RPS
6-7 Lovers Walk
Brighton
BN1 6AH

Date: 29th April 2014

GRUNDON FORD SITE: REPONSES TO FURTHER COMMENTS RAISED BY ACOUSTIC ASSOCIATES SUSSEX LTD

Figure 1: Plan Indicating Extent of Proposed Noise Barrier

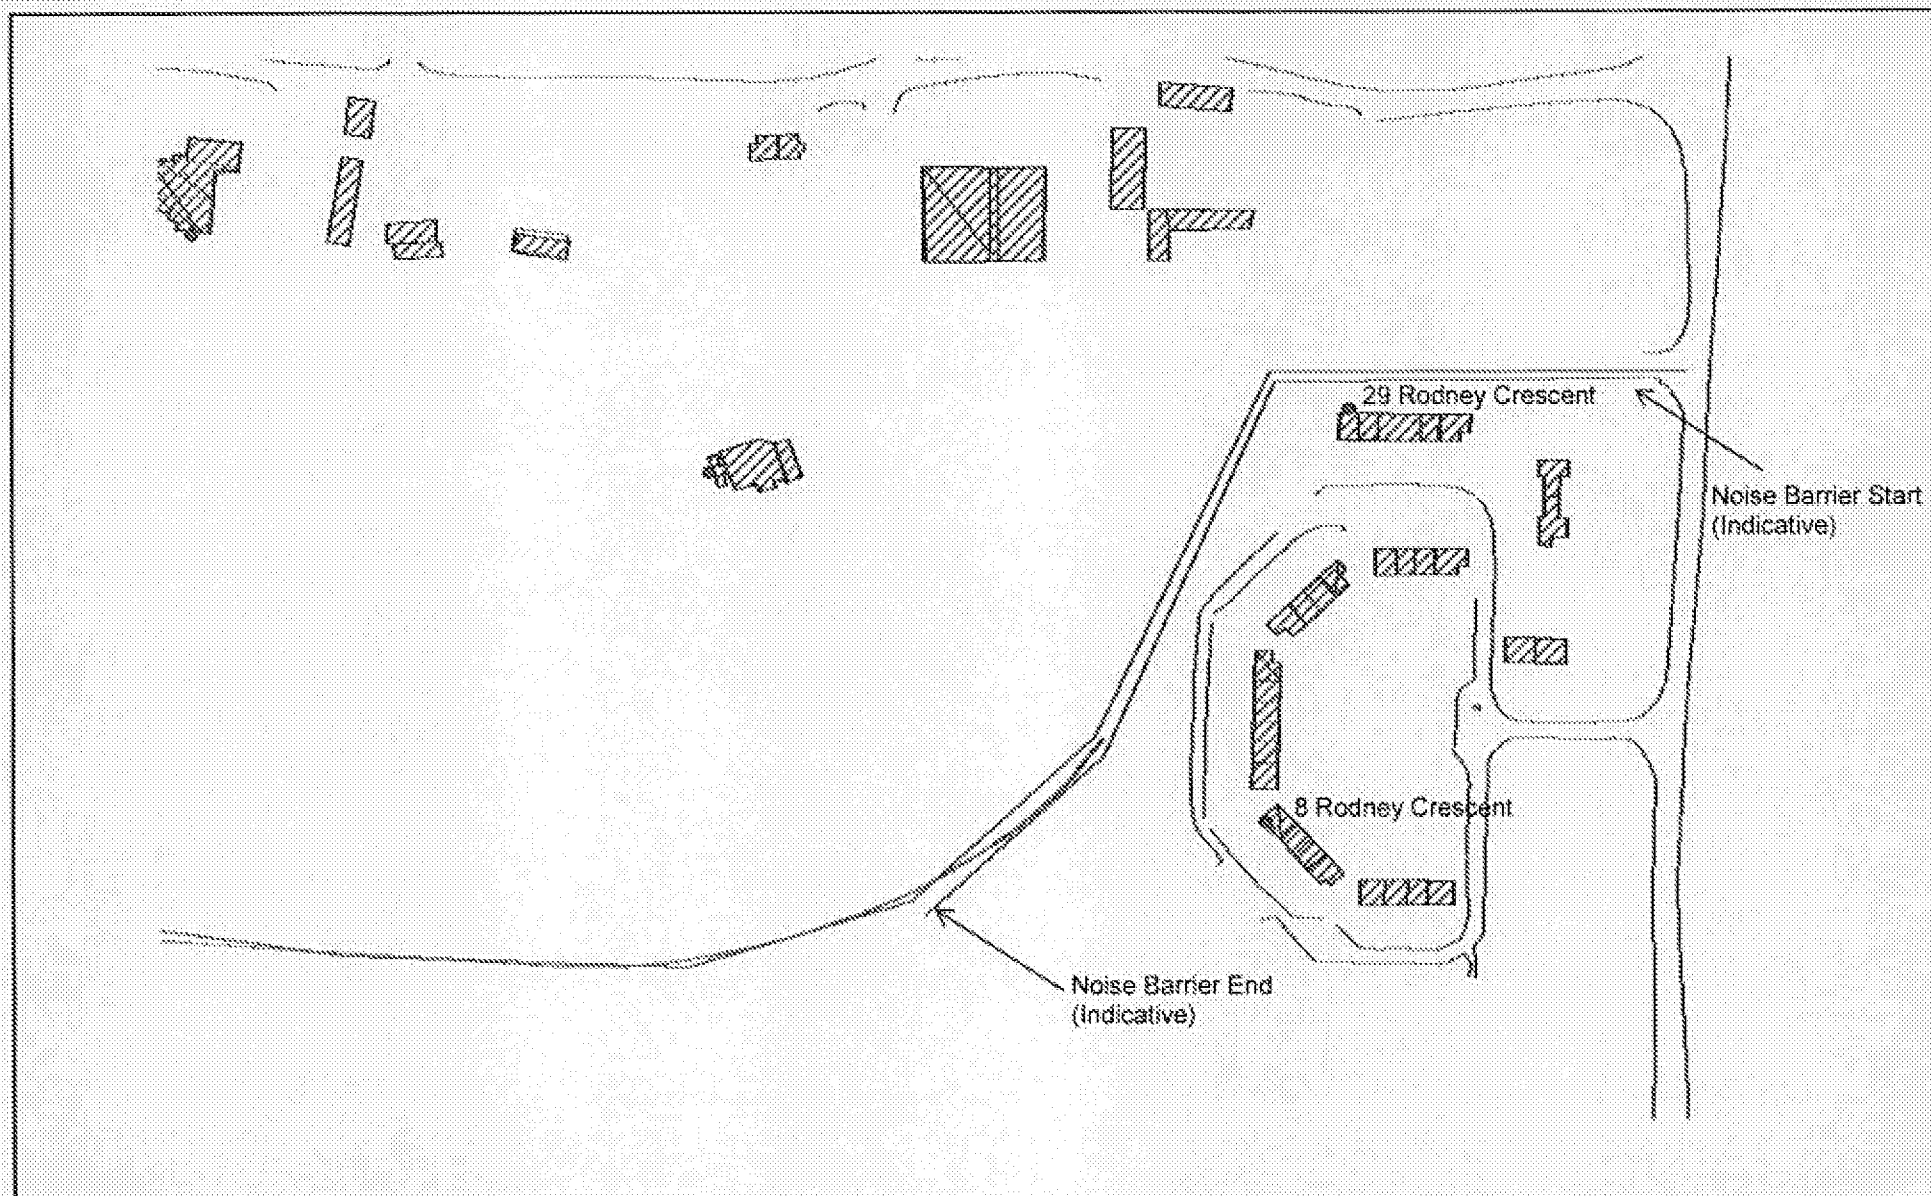
- 2 In particular, the following requests were made:
 - 1) that the HGV source term used for the assessment in the Environmental Statement (ES) be checked to confirm whether it had been appropriately modelled; and

- 2) that predictions of noise levels from construction vehicles on Rollaston Park be calculated and a comparison made to existing noise levels experienced from road traffic in this location.

- 7 As it has also now been proposed to install a 2 m noise barrier on the eastern access road to mitigate the noise levels at properties close to this road, this has now also been included within both the noise models for construction and operation of the site. The location and extent of the noise barrier is provided in Figure 1.

- 10 Within the ES, the assessment of internal noise levels in residential properties with respect to BS 8233 included noise from HGVs on the site access routes. This assessment has therefore been updated using the new source term, travelling at a speed of 30 km/h. The results of the noise model and resultant internal and external noise levels are provided in Table 3 below and in the noise contour plot provided in Figure 1 which also shows the location of the noise barrier.
